APPLICATION NO.	FILING DATE	FIRST NAMED INVENTOR	ATTORNEY DOCKET NO.	CONFIRMATION NO.
09/405,946	09/27/1999	PIERRE HILAIRE	ART9901	1073

Office Action Summary	Application No.	Applicant(s)
	09/405,946	HILAIRE, PIERRE
	Examiner	Art Unit
	Manuel Mendez	3763

DETAILED ACTION

FIG. 2

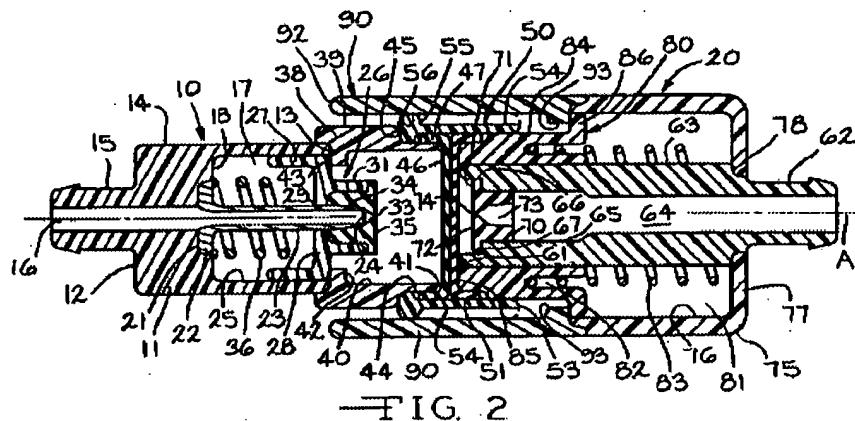
Claims 1 and 13 are rejected under 35 U.S.C. 102(b) as being anticipated by Mayer, U.S. Patent No. 5,470,319.

In figures 2 and 3 above, the cited patent discloses a connector body having a tubular portion (29) extending therefrom; and a valve body including a valve element (72) with a passage (74) therethrough, the valve body being axially movable with respect to the connector body; wherein the valve body is movable from a closed position in which said tubular portion (29) of the connector body is exterior to the passage (74) of the valve element to an open position in which the tubular portion (29) of the connector body is applied against the valve element (72) to at least partially open the valve element.

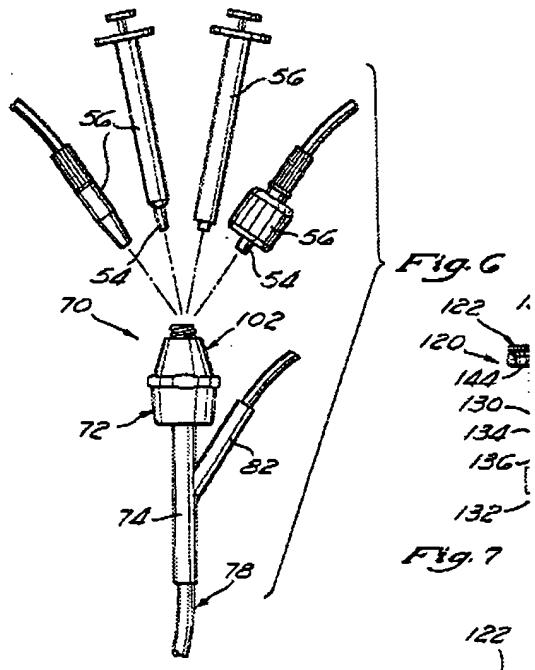
Claims 2-4, 7-12, and 16-19 rejected under 35 U.S.C. 103(a) as being unpatentable over Challender, et al., in view of Mayer. The Challender, et al. Patent does not disclose a connector body configured as a Y-shape connector. However, the design of Y-shape valve connectors is conventional as evidenced by the teachings of Mayer. The Mayer Patent demonstrates in figure 6 (below) that enhancing a valve-connector design with an additional Y-connector is conventional in the art.

Based on the conventionality of Y-connector designs, it would have been obvious for a person of ordinary skill in the art to enhance the Challender, et al. connector structure with the addition of a Y-connector. Accordingly, such modification would have been considered an obvious design alternative.
